**FRONT DOOR BELT MOLDING WIND NOISE**

To prevent a high pitch wind flutter noise caused by air rushing between the front door belt molding and outer door skin area, foam-backed tape has been added to the back side of the molding.

Starting VIN: FZJ80-0119754

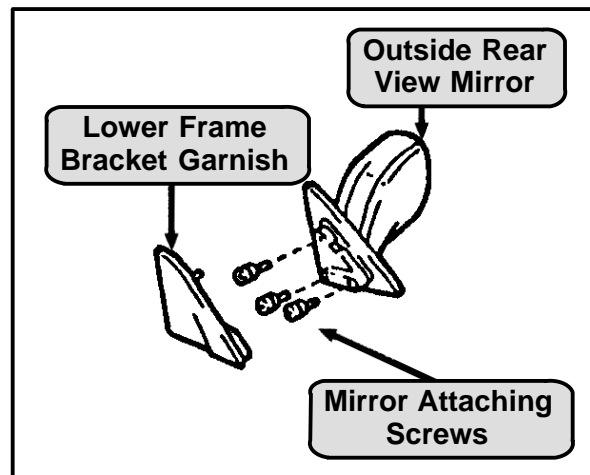
- Lower door glass to bottom of travel.
- Remove "Lower Frame Bracket Garnish" (triangular plastic screw cover plate located inside the vehicle at base of mirror).
- Remove the 3 mirror attaching screws and carefully pull mirror away from door frame.

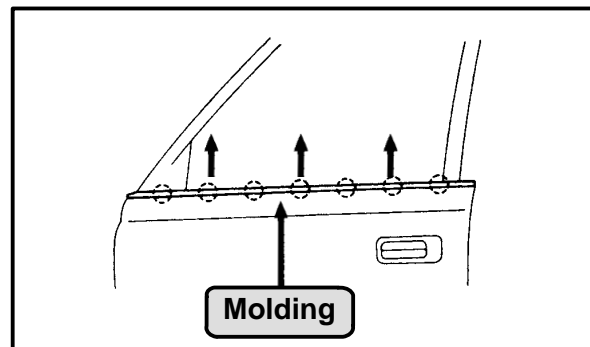
**NOTE:** Wrap door mirror with a shop towel and carefully drape door mirror against door.

- Remove belt molding attaching screw (located at rear inside edge of door frame).
- Grasp molding with 2 hands and pull molding straight up using a swift upward motion.
- Use needle-nose pliers to remove plastic attaching clips that remained attached to metal door panel when molding was removed.

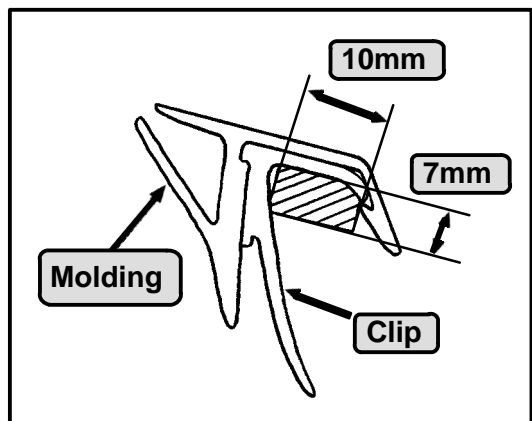
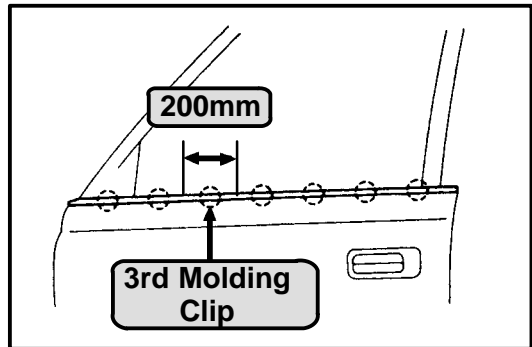
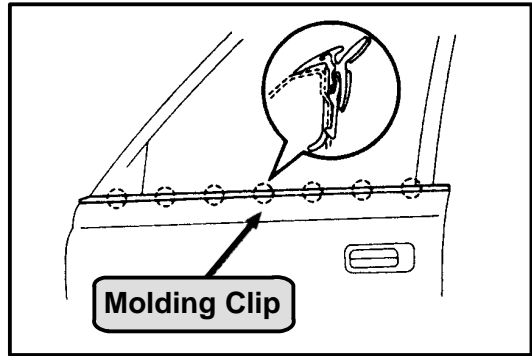
- Reinstall plastic attaching clips to back of belt molding.

**NOTE:** Place clips in the factory location. Original location is easily determined by the small scratch marks left on the back side of the molding by the clips.

- **Center** and adhere a piece of foam backed tape (from the Toyota Squeak and Rattle Kit, P/N 08231-00801) to the back side of the molding, directly over the third clip (3rd clip counting from the front edge of the molding).

**NOTE:** Tape should be approximately 10 mm wide X 7 mm thick X 200 mm long.
